## **Proposal for draft amendments to UN Regulation No. 79 to differentiate the scope of UN Regulation No. 79 and the draft DCAS UN Regulation**

### UN Regulation No. 79

#### Uniform provisions concerning the approval of vehicles with regard to steering equipment

### Arrangements of approval marks

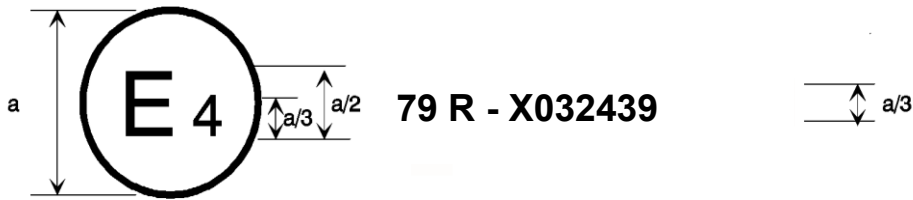
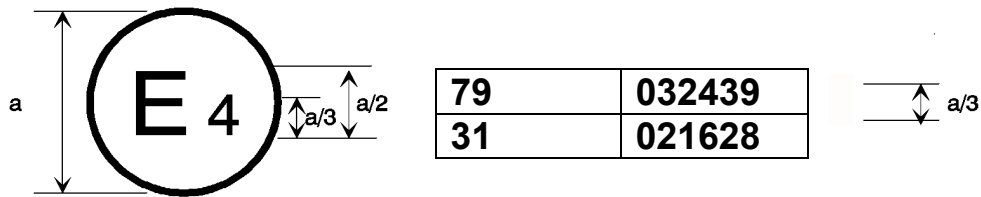
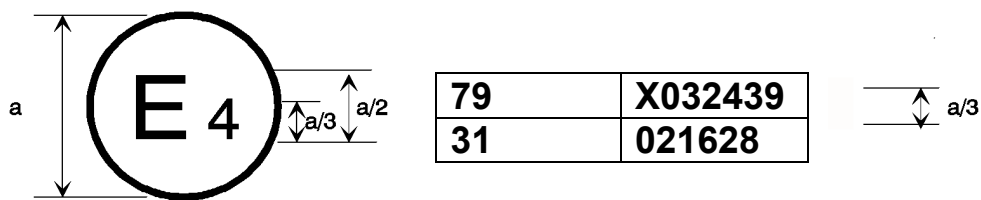
The above approval mark affixed to a vehicle shows that the vehicle type concerned has, with regard to steering equipment, been approved in the Netherlands (E 4) pursuant to UN Regulation No. 79 under approval No. 032439. The letter “X” preceding the approval number indicates that the vehicle is equipped with ACSF or RMF which has been exempted from the requirements of this UN Regulation, and/or that the vehicle is equipped with a steering system which exhibits functionality defined as an ACSF of Category B2, D or E. The approval number indicates that the approval was granted in accordance with the requirements of UN Regulation No. 79 incorporating the 03 series of amendments.

The above approval mark affixed to a vehicle shows that the vehicle type concerned has been approved in the Netherlands (E 4) pursuant to Regulations Nos. 79 and 31.<sup>4</sup> The letter “X” preceding the approval number pursuant to Regulation No. 79 indicates that the vehicle is equipped with ACSF or RMF which have been exempted from the requirements of this UN Regulation, or that the vehicle is equipped with a steering system which exhibits functionality defined as an ACSF of Category B2, D or E.. The approval numbers indicate that, at the dates when the respective approvals were given,

A new marking provision is added so that approvals to Regulation 79 which have made use of the provisions specifically relating to DCAS ~~and/or R157~~ can be identified, and therefore Contracting Parties who do not apply ~~either of those regulations~~ R[DCAS] can assess whether a Regulation 79 approval is valid in their territory or not.
